October 18, 2011

ISSUED FOR USE EBA FILE: W14101068.037

Subject: Dry Stack Tailings Storage Facility – 2011 Annual Review Minto Mine, YT

Figure I Site Plan with Observations

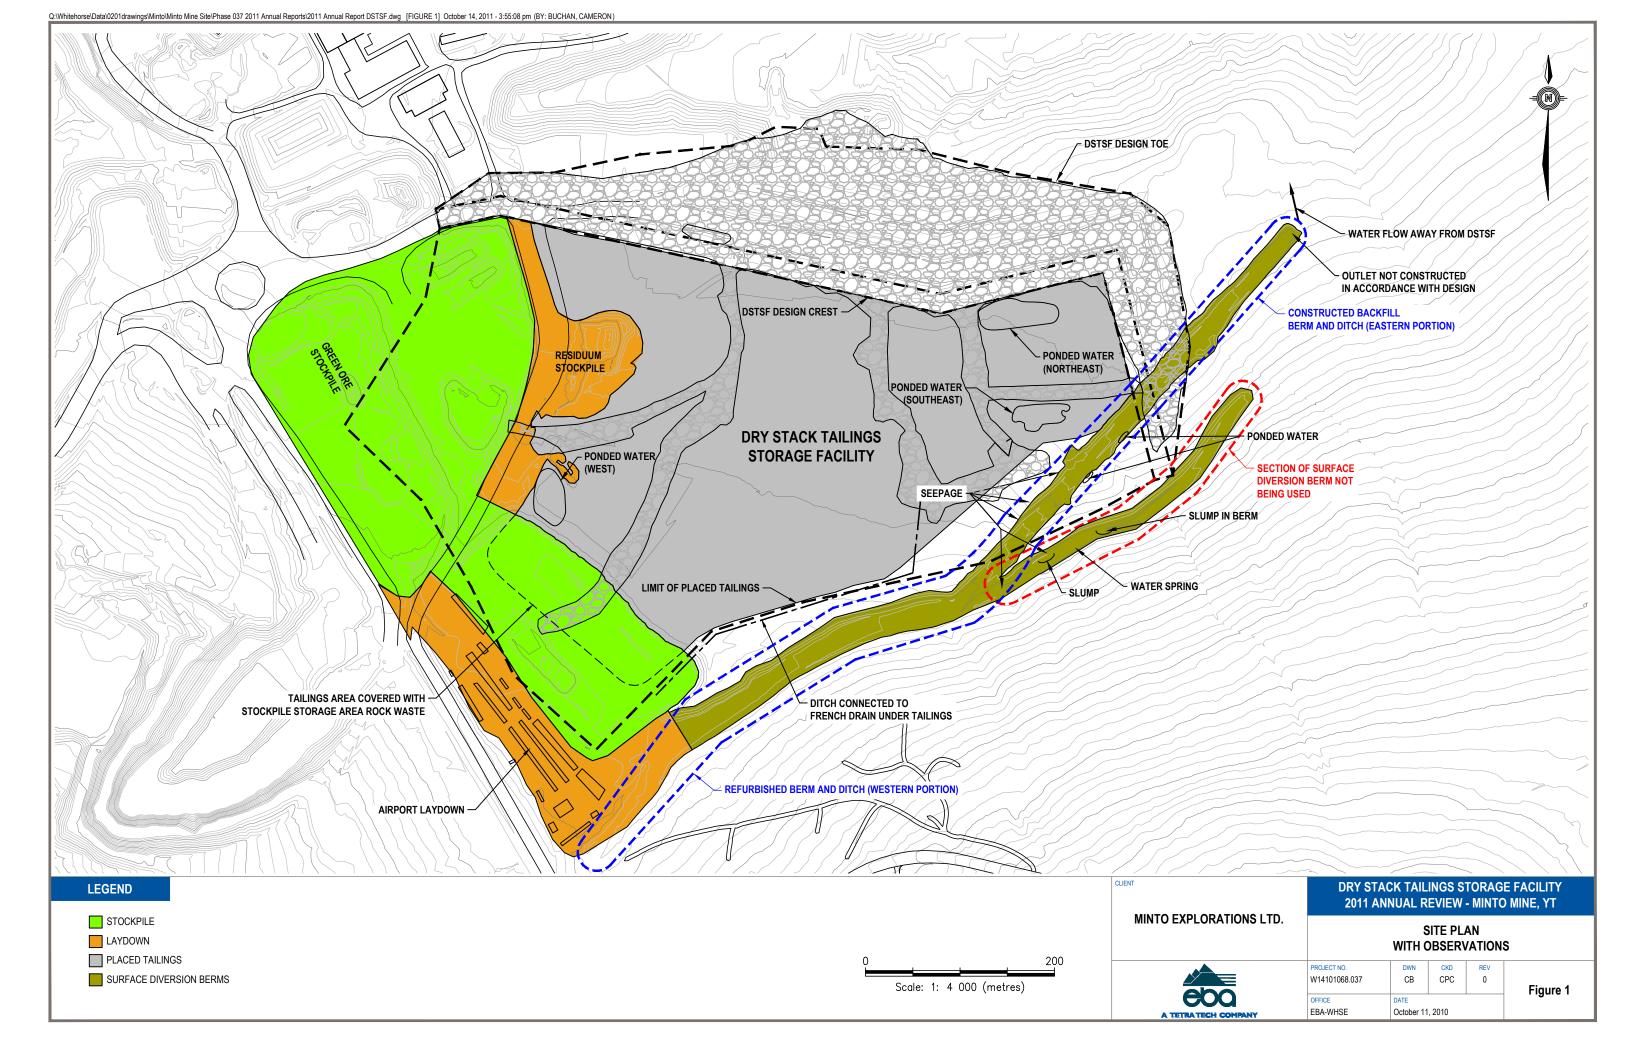
- Water ponded over the areas of tailings upstream of bench 7 was noted in three locations, the west portion, the northeast portion, and the southeast portion within the facility shown on Figure 1 (Photos 5, 6 and 7). In all three cases, the water was observed as murky. The ponded water in the west portion of the facility can be attributed to possibly run-on surface water and water flowing under the liner at various locations along the South Diversion Ditch. The ponded water in the northeast portion of the facility can be attributed to melting snow that was stockpiled in the area during the previous winter. The ponded water in the southeast portion of the facility can be attributed to melting snow that was stockpiled in the area during the previous winter. The ponded water in the southeast portion of the facility can be attributed to melting snow that was stockpiled in the area during the previous winter. The ponded water in the southeast portion of the facility can be attributed to surface water run-on from southeastern slope of the facility.

- The additional section of the berm constructed south of the eastern portion of berm with ditch (surrounded by the red dashed line on Figure 1) is performing much in the same manner as it was during the 2010 inspection; several high points in the ditch have caused water to pond on the uphill side of the berm. Seepage was noted at several points along the downhill side of the berm along this portion. This seepage water was noted ponding on the uphill side of the rockfill berm and seeping into the tailings area in several areas (Photos 11 and 12). Therefore, run-on water from this section still flows into the tailings area.

It is recommended that the surface diversion berm be rehabilitated to effectively capture water along the entire length of ditch. Minto has engaged EBA in providing a updated design (September 14th, 2011 Issued for Review EBA Technical Memo 013.06 titled "Upstream Water Management for the Mill Valley Fill Expansion and Dry Stack Tailings Storage Facility") but the implementation is dependent on a lease boundary extension, which is pending. After rehabilitation, maintenance issues are expected and maintenance issues will need to be addressed throughout its use.

The discharge location of the lined ditch should be constructed in accordance with the September 14th, 2011 Issued for Review EBA Technical Memo 013.06 titled "Upstream Water Management for the Mill Valley Fill Expansion and Dry Stack Tailings Storage Facility".
